**SUBJECT:** (7.3) Carabella Street, Kirribilli - Proposed Raised Pedestrian Crossing

**AUTHOR:** Report of Traffic & Transport Engineer, Iman Mohammadi

**SUBJECT:** (4.8) Carabella Street, Kirribilli - Proposed Raised Pedestrian Crossing – Survey Results

**CONCEPT**

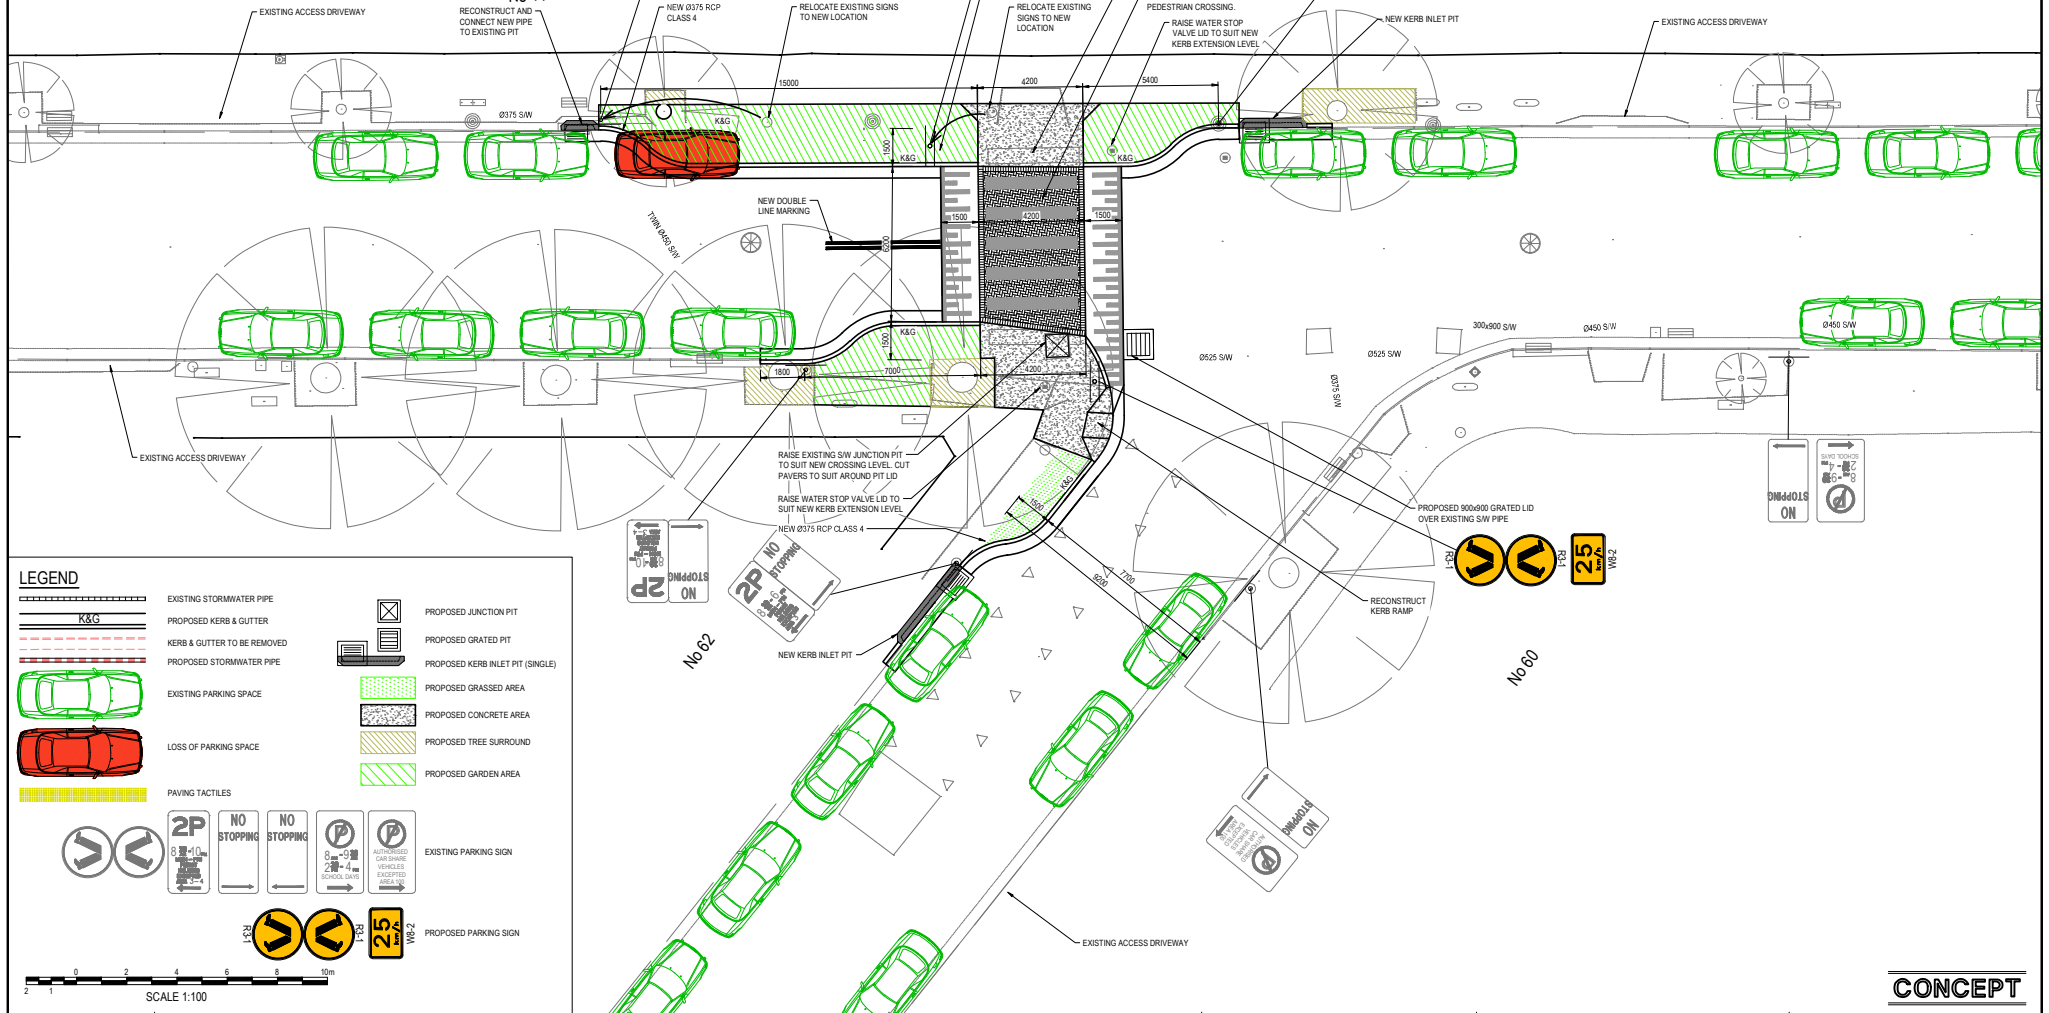
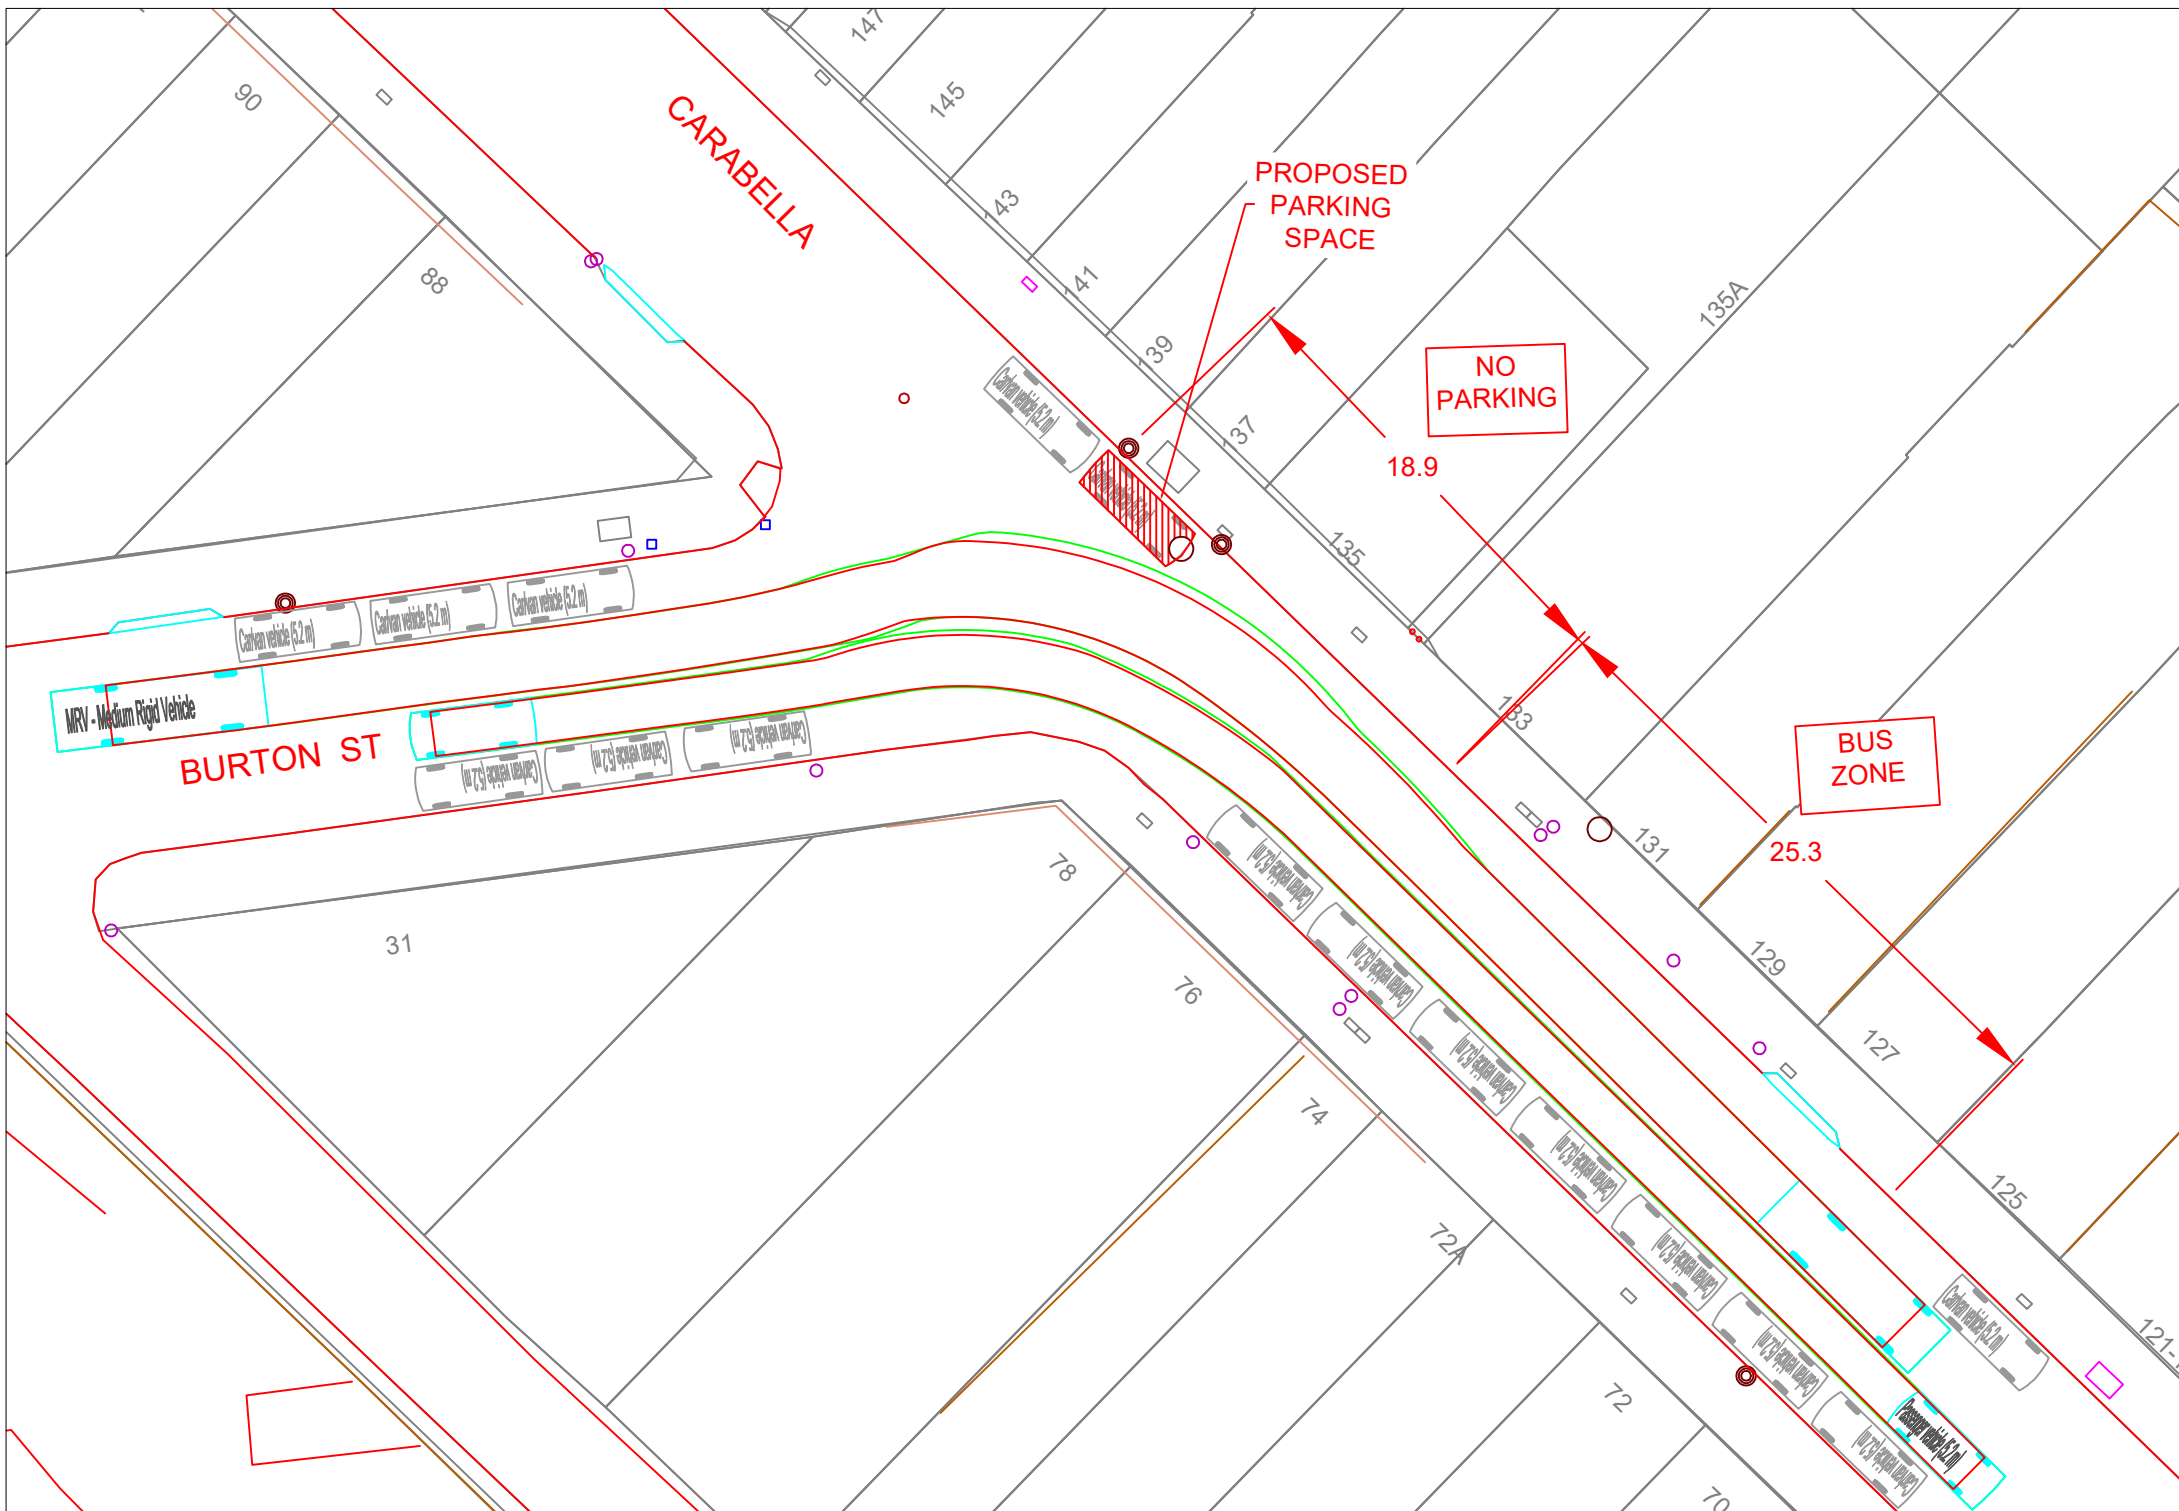
MOTION: Carabella St. Pedestrian Crossing at Fitzroy St: Milson Precinct does not support this proposal, with the loss of a car parking space on Carabella St. The current management system should be retained, using the lollipop man during school days. This is unnecessary expenditure, especially given the loss of a car parking space.

- Submission regarding Carabella Street Raised pedestrian crossing  
I Object to the current plan for Carabella street raised crossing in its current proposed form because it needs a little bit of work on it to make it work perfectly and functionality in a very busy area with lots of vehicles and people, and the high need for parking. There will be a way for you to do it without having the garden bed and losing parking, potentially by giving some more thought to the design.  
Is the design and loss of a parking space, pretty much just to incorporate double lines which have never been in this street for all my schooling at the school for over 20 years. It would make it very difficult for people to manoeuvre and go along the opposite way of the traffic because of the school pick up line which happens on a daily basis whenever there is school in operation 40 weeks of the year. The people do it very carefully at the moment . By this design you'd be making them actually break the law so you have to have people here to enforce the road rules. By having people there to enforcing the road rules, by this design, you will actually be impeding the flow of traffic even further, causing a gridlock in the surrounding streets and areas to a greater degree than what it currently is, because of the restrictions on manouvrality of this design, especially when it's schools pick up times.

A solution would be to have some markings on the road which means it would still be functional because these roads have had no markings on them for years. Why is this small section of double lines only on one approach and section of this road? Why is it not in the rest of the street, as it would not be functional in the street, as it would wreck the parking opportunity, as many properties do not have off street parking. So every parking spot matters in this context. Rather than a single broken line for the whole street, which would slow the traffic and still allow the street parking.  
I object to the Proposed Raised Crossing, as it has garden bedding which would take out a parking spot but also with some of that garden bed is where the cars for the school pick up currently pull into that area and wait so as not be across the crossing or across in the middle of the Fitzroy Street intersection to allow traffic to continue moving slowly when it is school pick up time.

All low shrubbery is likely to be walked all over by school students. Your plans show a narrowing of the footpaths on both sides of Carabella St, which is madness when students currently walk 2-4 abreast, so plants will be getting squished. They are more likely to be crossing thru young garden beds, to cross with their friends, while the lollipop man is stopping the traffic. A greater area for waiting by students at the crossing, would be more effective. Especially when you have different age groups supervised by teachers, to get to other services within the local area - bus or trains, or school swimming classes at NSOP and mandatory learn to swim and water rescue classes.

Parking spots are always in use in Kirribilli and that spot that you're proposing to get rid of, is pretty much always occupied by a vehicle and all of the school cars are aware of it because they all know to manoeuvre around that space, when they form the school pick up line because you'll have one or two cars on either side of the pedestrian crossing waiting to get further up in the queue for school pick up.

- Raised kerb at pedestrian crossing on Fitzroy and Carabella will affect fire trucks, ambulances or other emergency vehicles from parking or allowing other vehicles to pass them while they are attending emergencies. Also traffic would be more congested on Carabella when parent cars line up to pickup their children from Loretto college.

- Water coming down Fitzroy Street, after torrential rains, is similar to that which comes down Bligh St., which took out a wall 24 years ago on my property, and in NSC review of 'flood' impacts, changed all the properties along Carabella St. to be flood prone. The Bligh St. water egress was address by additional new kerb inlet pits, some 8-10 years ago. I feel that the proposed kerb inlet pits shown on the concept plan 20D97\_SK\_C111 no.2, dated Nov2020 should be implemented anyway, regardless of the proposed pedestrian crossing, to avoid additional water ingress down the Loreto / Tremayne existing driveway. Thanking you for your consideration of these matters.

**THAT** Council, as part of the 2020/21 LATM Program, convert the existing marked foot crossing on Carabella Street at Fitzroy Street to a raised pedestrian crossing, as shown on plan 20D97\_SK\_C11, after the affected properties are notified by letterbox delivery.
